CLEEVES RIVERSIDE QUARTER

Document title: Quality Audit Report

Road Safety Audit Stage 1 Report

Figure 3-1 – Set Down/ Accessible Car Parking Bay

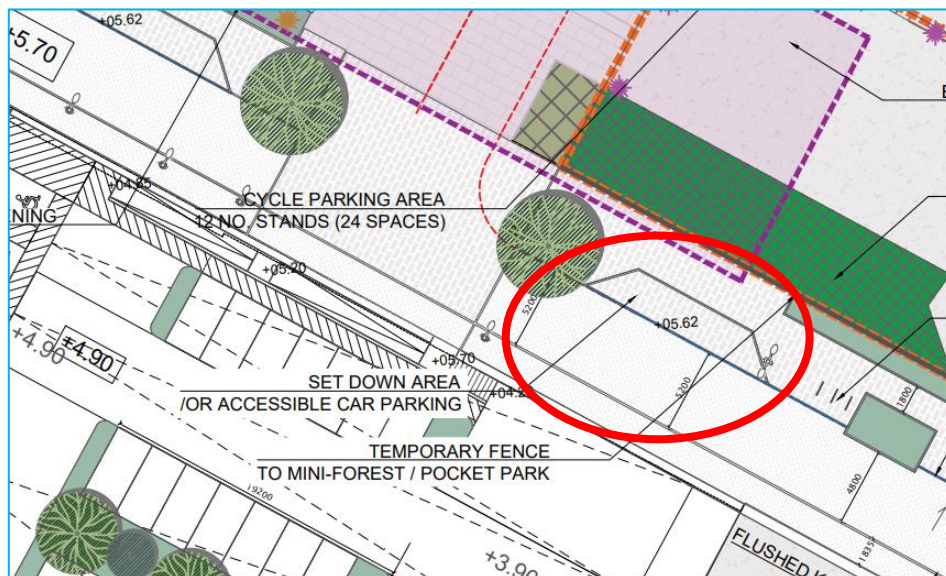
The proposed set down area/ accessible car parking bay location on the North Circular Road does not indicate the associated dropped kerb and blister tactile paving. It is unclear if the space is sufficiently wide to cater for mobility impaired users. The absence of such features may compromise the usability of the facility and increase the risk of conflict if users need to navigate to the road while using the space.

A parking space with suitable width, dropped kerbs and blister tactile paving should be provided.

3.4.1	Yes	Yes		
3.4.2	No	No	This is not an accessible car parking space. Drawing tag will be updated.	Yes. Noted and agreed.
3.4.3	Yes	Yes	The suggested improvements to the existing pedestrian ramp will be considered in the next design stages and in the context of future proposals for commercial accommodation in Phase IV of the masterplan.

Figure 2-1 – Shared Space

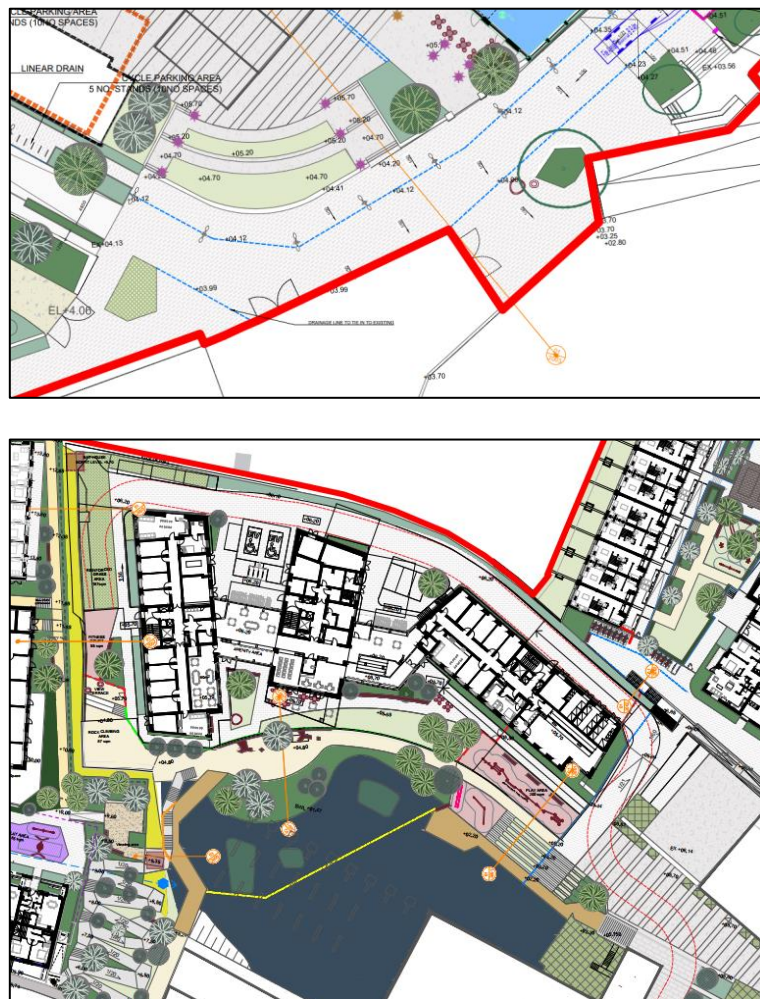
It is unclear from the drawings provided by the Designer whether non-physical delineation features, such as surfacing or different textures or colours, will be implemented within the shared spaces throughout the scheme to aid in guiding vehicles away from pedestrian only zones. Measures to curtail vehicles speeds in these zones are not clear in the design drawings. These zones are particularly important for individuals with mobility and visual impairments. A lack of clearly defined pedestrian only zones, speed control and appropriate delineation may result in vehicle/ pedestrian conflict within the shared space and create navigation difficulties for users with mobility and visual impairments.

The Designer should ensure the proposed layout gives particular attention to the provision of pedestrian only zones within the shared spaces, and that robust speed control measures are provided throughout any shared space zones.

2.1	Yes	Yes		
2.2	Yes	Yes	The design will be updated to accommodate improvements to pedestrian circulation within close proximity of the proposed scheme.

Figure 2-3 – Missing Detail at Tie-In

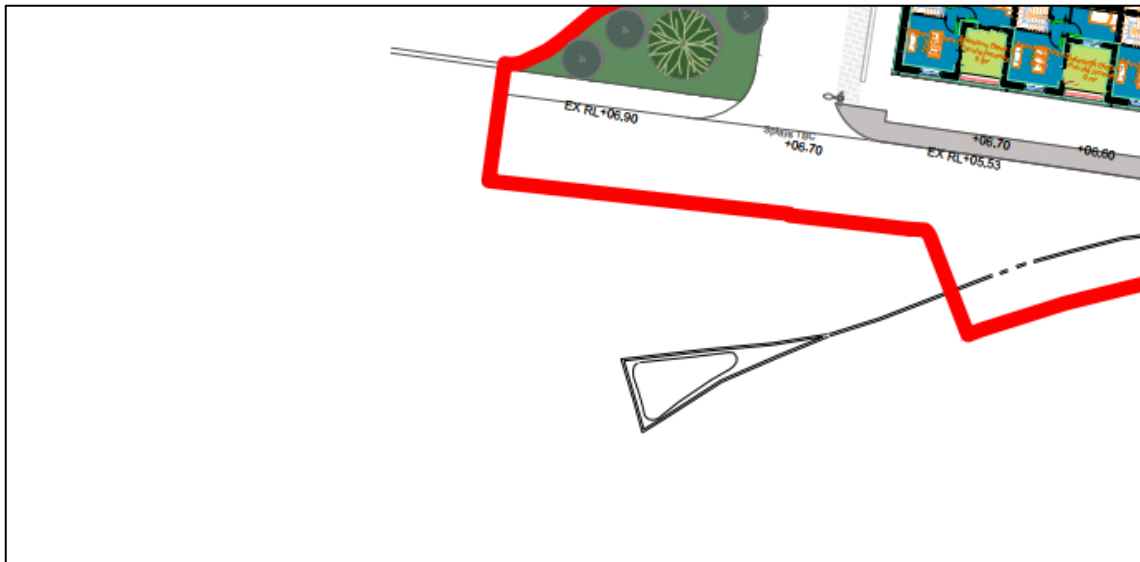
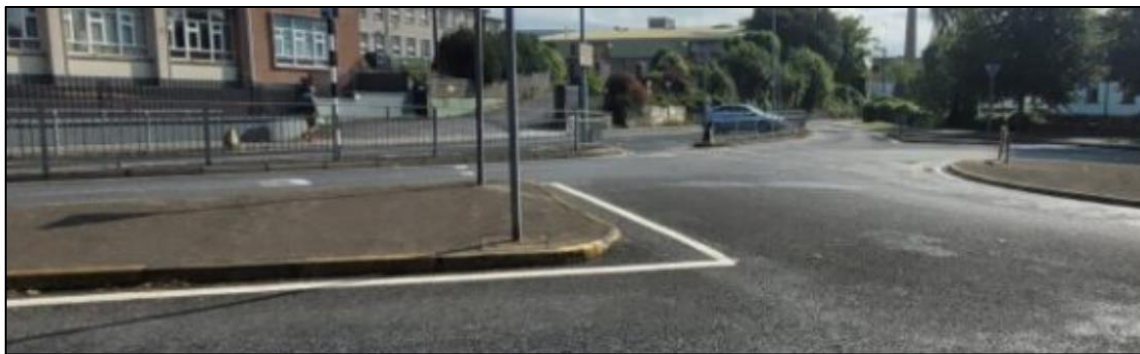
The proposed access point for the western end of the development is into an existing drop off/ pick up area adjacent the roundabout and school. This may lead to potential conflict between vehicles entering/exiting this area and this utilising the drop off/ pick up area which may inadvertently travel against the flow of traffic, increasing the risk of head on collisions with vehicles. People being dropped off in this area are at risk of being struck by vehicles traveling to and from the development.

The design should suitably tie-in into the existing road network ensuring that the drop off area is catered for. The layout should be suitably amended in conjunction with problem 2.8 above to cater for pedestrians in this area.

2.3	Yes	Yes	Minor improvements to kerbs are proposed that will better this arrangement. Volume of traffic for proposed development only increased by 5no. accessible spaces and 2no. creche drop-offs at this entry point to the site from existing condition.

Figure 2-5 – Uncontrolled Crossings

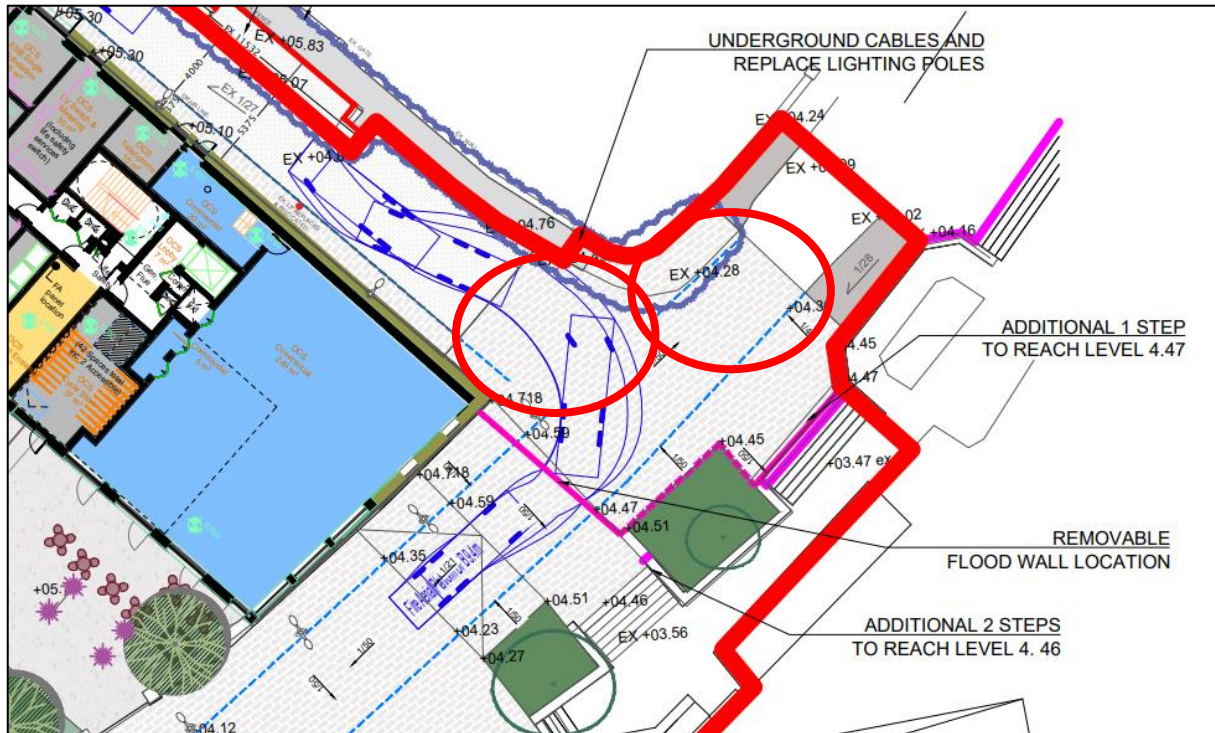
It is unclear from the drawings provided whether the existing uncontrolled pedestrian crossings at the junction of O'Callaghan Strand and Stone Town Terrace are to be retained or modified as part of the proposed layout. The absence of clearly designated crossing points may lead to conflicts and collisions between vehicles and pedestrians, particularly those with visual impairments who rely on provision of tactile paving for safe navigation.

The Designer should clarify the treatment of existing uncontrolled pedestrian crossings in the proposed layout. If crossings are to be retained or modified as part of the proposed layout, the Designer should ensure that appropriate tactile paving is included in the design to support the safety of non-motorised road users, particularly those with visual impairments.

Figure 2-6 – Uncontrolled Crossings

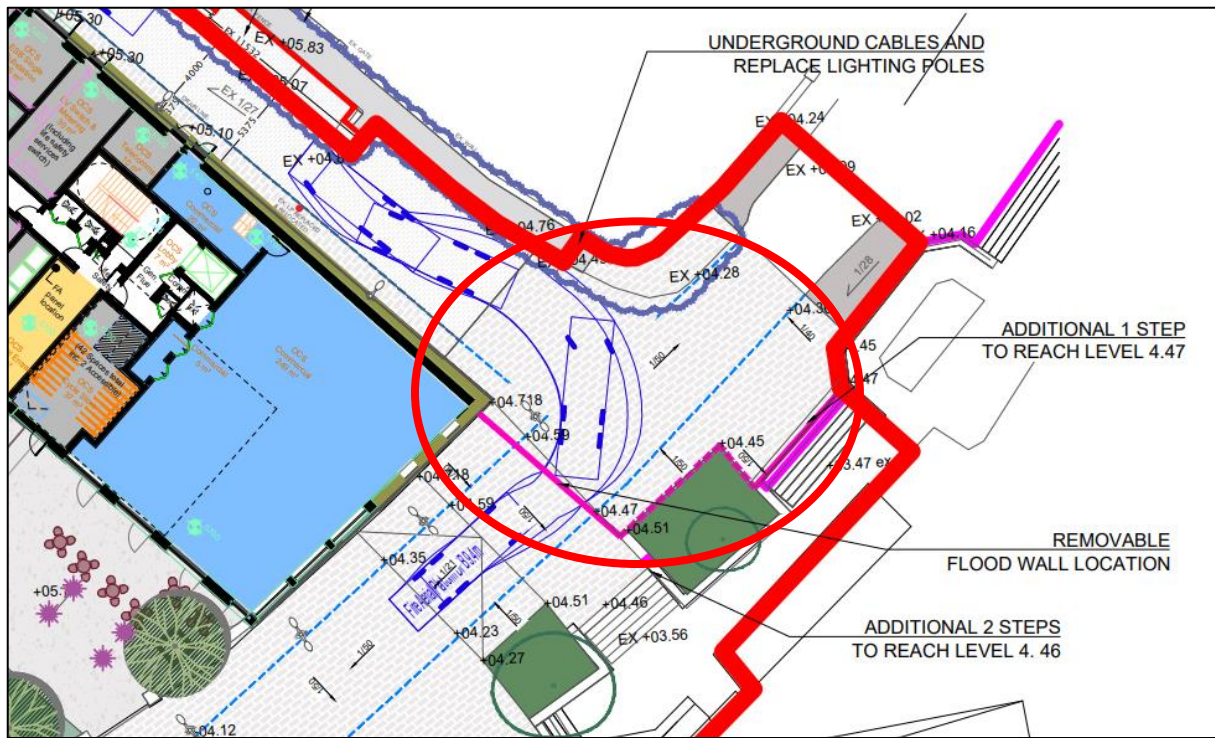
It is unclear from the drawings provided by the Designer whether any protection measures are being considered for inclusion at the uncontrolled pedestrian crossing, to safeguard vulnerable road users waiting to cross. There is general lack of segregation in this area which could leave pedestrians and vulnerable road users exposed to through traffic. The lack of delineation using kerbs at this junction may result in large vehicles entering the pedestrian only zones while completing a turn, increasing the risk of vehicle/ pedestrian type collisions.

Appropriate physical protection measures to clearly delineate pedestrian space and enhance safety for vulnerable road users should be provided here and all conflict points in the scheme.

Figure 2-7 – Blind Corner at Gated Access

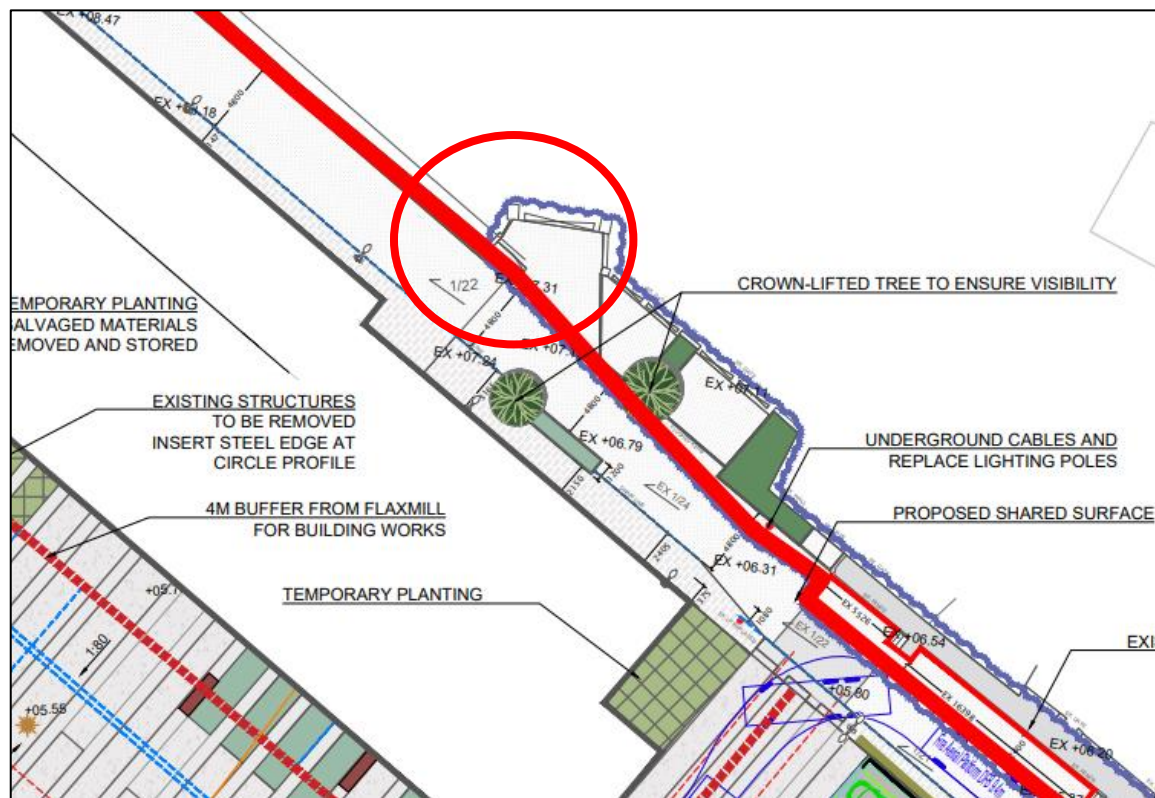
During the site visit, the Audit Team observed a visibility obstruction for vehicles exiting the gated residential complex onto Stone Town Terrace. This may increase the risk of collisions between vehicles leaving the property and pedestrians/cyclists along the shared surface.

Ensure appropriate sightlines at the locations noted above are provided.

Figure 2-8 – Blind Corner at Ancillary Room

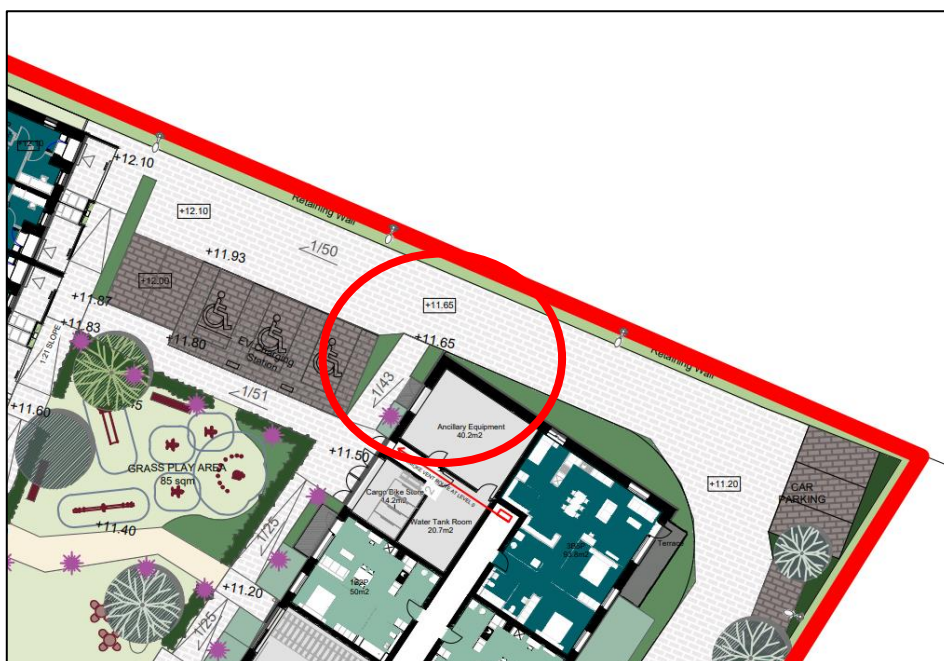
A similar concern related to the location highlighted below.
